Addendum Development Form

Letting Date: May 13, 2014
 Proposal Number: 03
 Proposed Addendum No.: 01
 Project ID: 1390-04-79
 Federal ID: WISC 2014 890
 Project Description: Janesville – Fort Atkinson
 Town Line Road – CTH N
 STH 26
 Rock County

This is Addendum No. 1, which provides for the following:

ADDENDUM NO. 1

Addendum No. 1
ID 1390-04-79
Revised Sheet 529
March 26, 2012

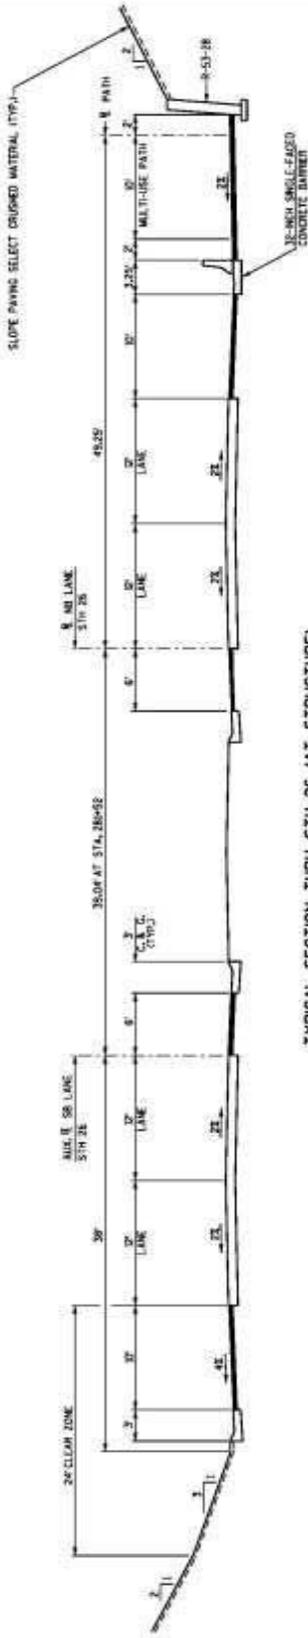
Revised: 51, 52, 59, 250, 251, 256, 266, 279, 529, 625, 630, 635, 648, 653, 658, and 706.

Addendum No. 1
ID 1390-04-79
Revised Sheet 658
March 26, 2012

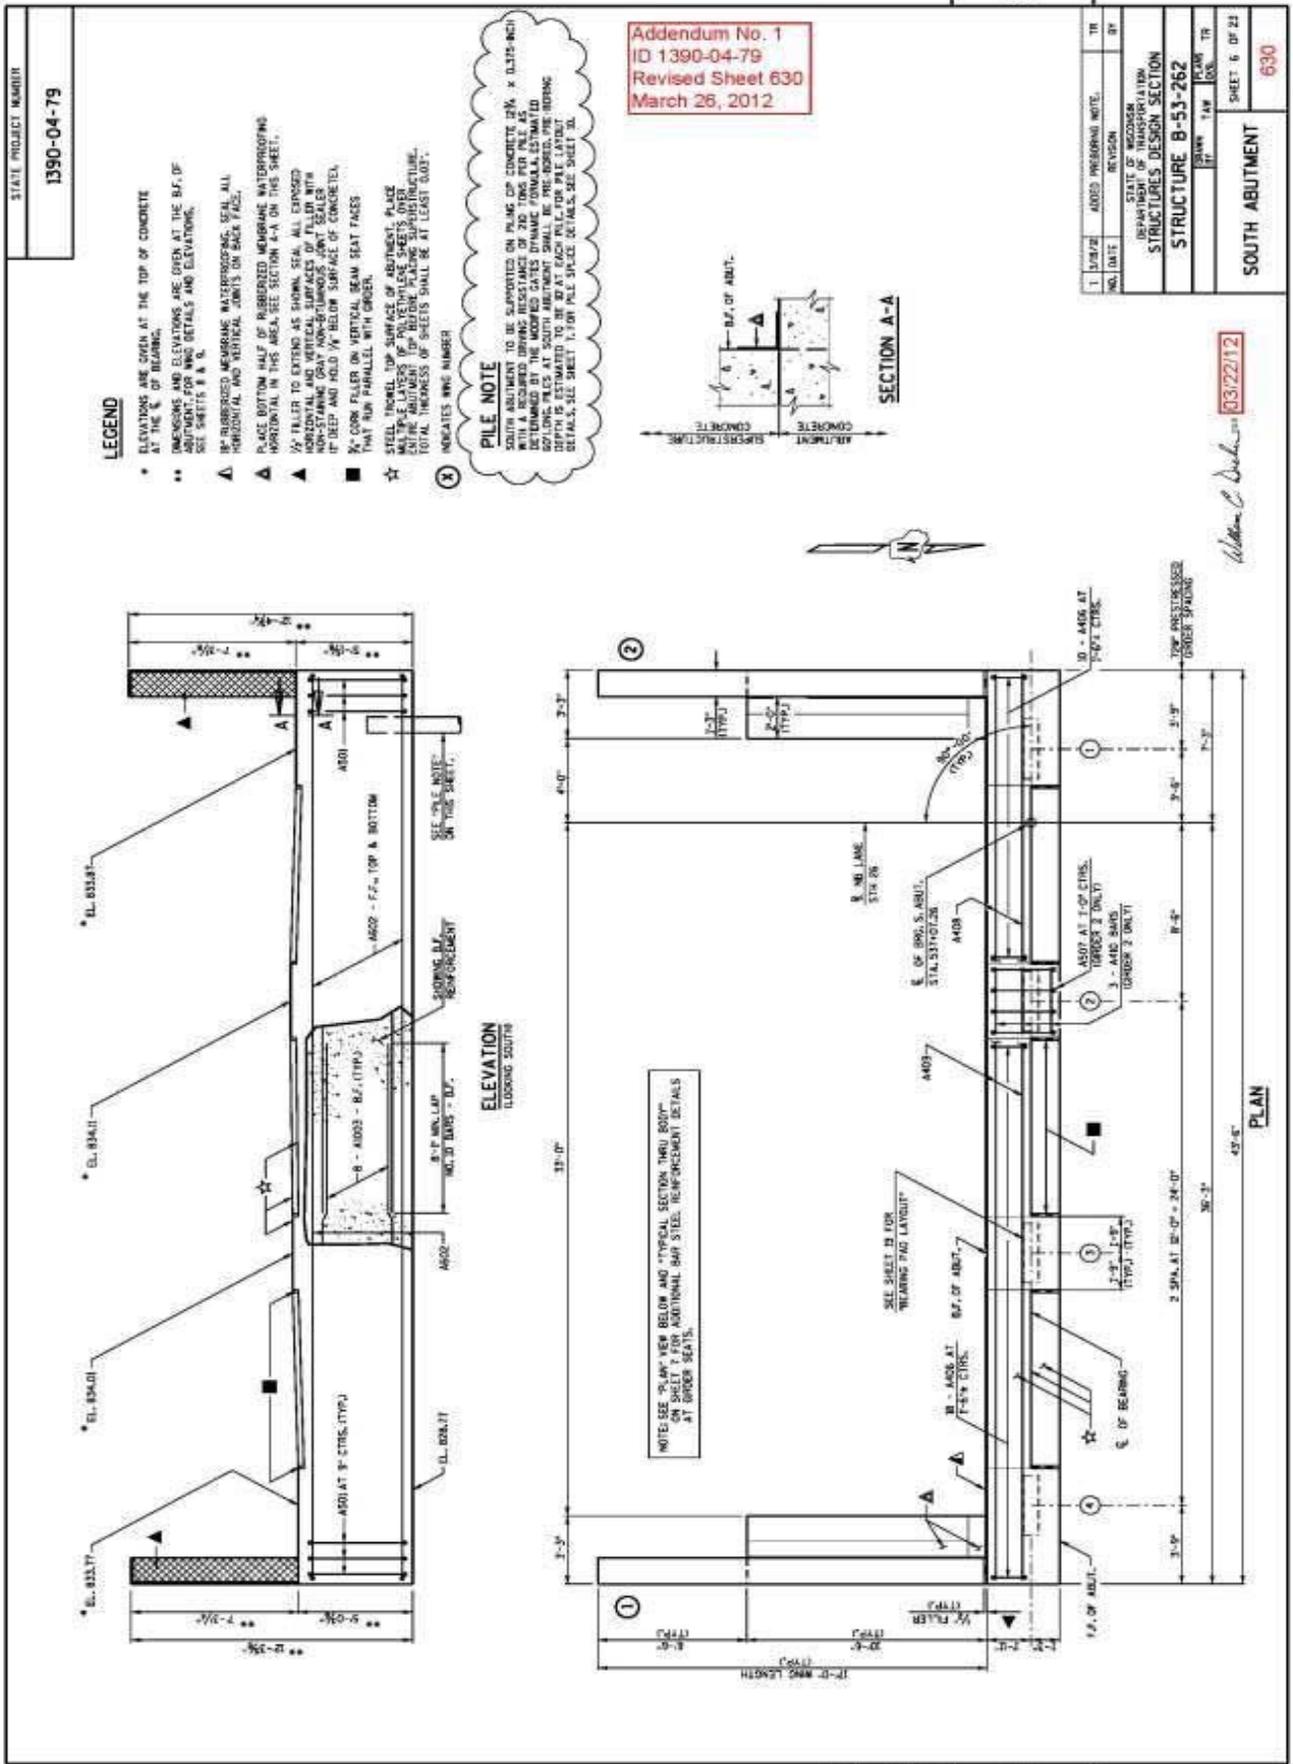
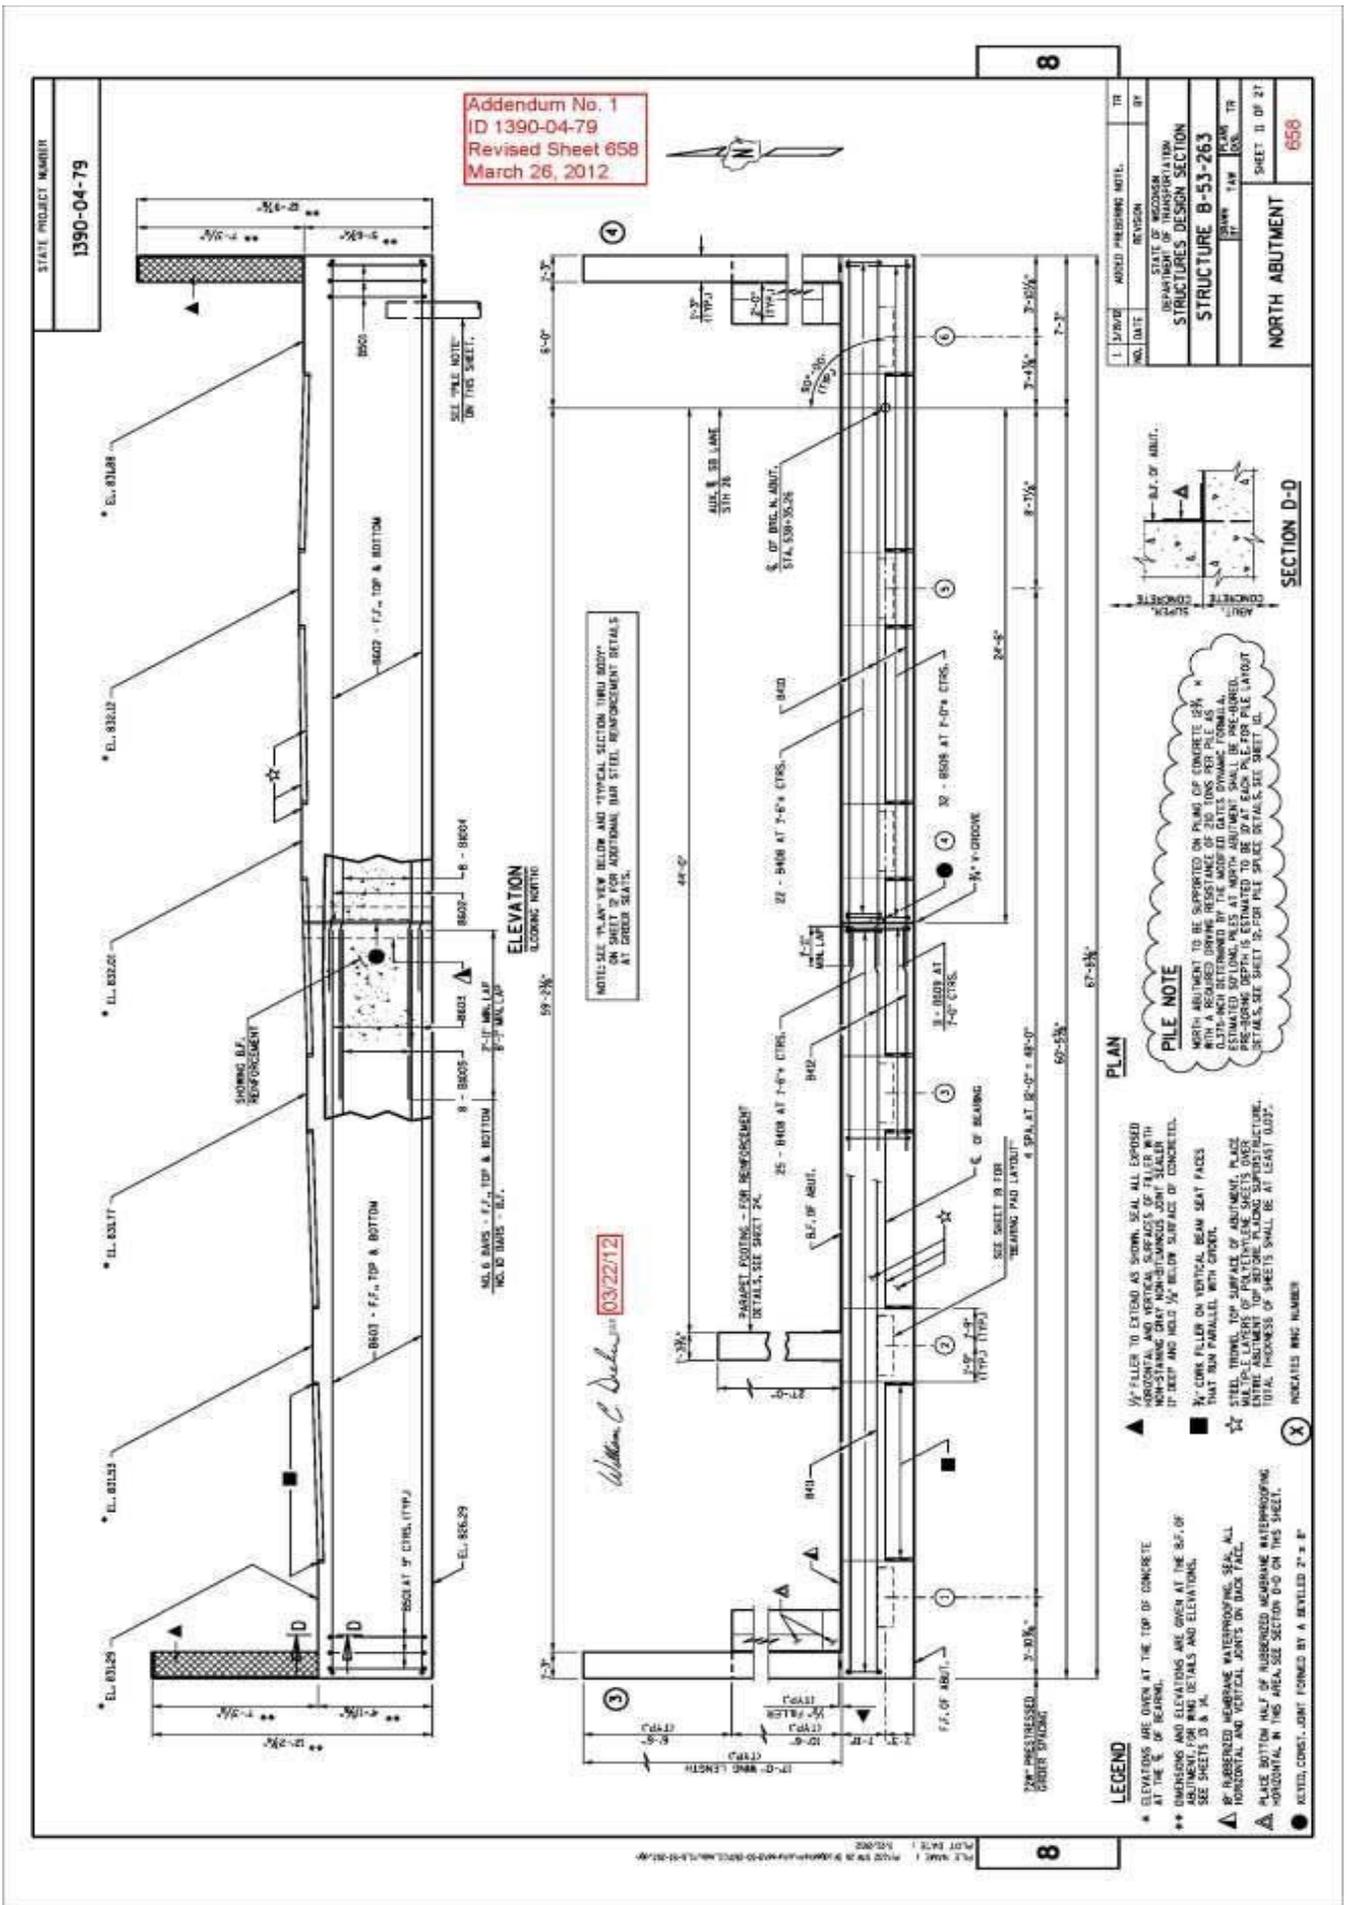
Revised structure sheets 625, 630, 635, 648, 653, & 658 for B-53-262 & B-53-263 to include a note that explained how much pre-boring is estimated for each abutment.

Structure sheets 625, 630, 635, 648, 653, & 658 for B-53-262 & B-53-263 were revised to include a note that explained how much pre-boring is estimated for each abutment. Structure sheet 706 was revised to reflect the correct elevation at the beginning of the wall.

251	Miscellaneous Quantities (revised quantity sheet to add item for removing old structure for existing box culverts at 569+06; 152+96 'PV'; & 6+72 'PV')
256	Miscellaneous Quantities (revised removing small pipe culvert quantity to remove quantities for culvert at 569+06; 152+96 'PV'; & 6+72 'AH')
266	Miscellaneous Quantities (added additional Light Riprap quantity and additional Geotextile fabric type R)
279	Miscellaneous Quantities (added Geogrid Reinforcement quantity table)
529	Structure B-53-250(revised quantity for item 550.0010.S Pre-boring (Unconsolidated Materials) from 600 to 960)
625	Structure B-53-262 (revised first note under Foundation Data)
630	Structure B-53-262 (revised Pile Note)
635	Structure B-53-262 (revised Pile Note)
648	Structure B-53-263 (revised first note under Foundation Data)
653	Structure B-53-263 (revised Pile Note)
658	Structure B-53-263 (revised Pile Note)
706	Structure R-53-028 (revised Begin Wall elevation)

PILE NOTE
NORTH ABUTMENT TO BE SUPPORTED ON PILES OF CONCRETE 24" DIA. WITH A REQUIRED DRIVING RESISTANCE OF 210 TONS PER PILE AS DETERMINED BY THE MODIFIED GATES DYNAMIC FORMULA. PRELIMINARY DEPTH IS ESTIMATED TO BE 40' AT EACH PILE. FOR PILE LAYOUT DETAILS, SEE SHEET 12 FOR PILE SPACING DETAILS. SEE SHEET 12.

Addendum No. 1
 ID 1390-04-79
 Revised Sheet 705
 March 26, 2012

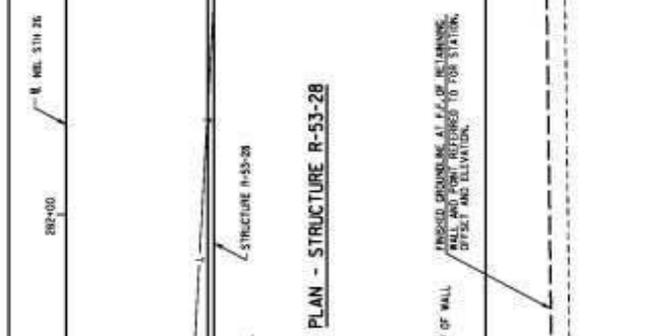
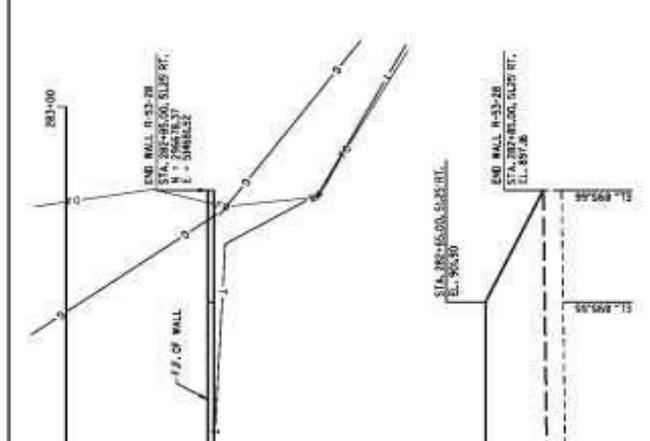
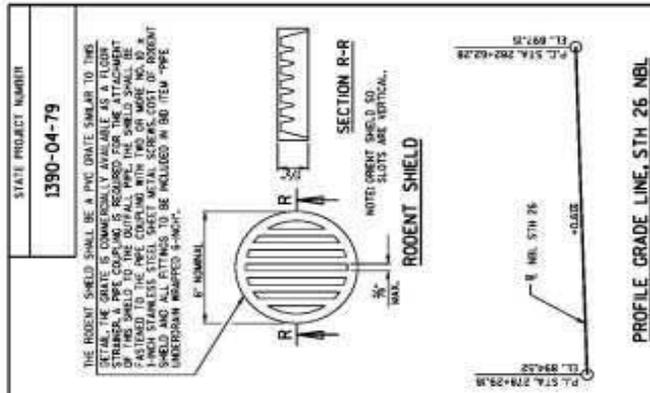
Revised structure sheet 706 to reflect the correct elevation at the beginning of the wall.

THE RETAINING WALL IS TO BE DESIGNED USING THE ELEVATIONS SHOWN ON THIS SHEET.
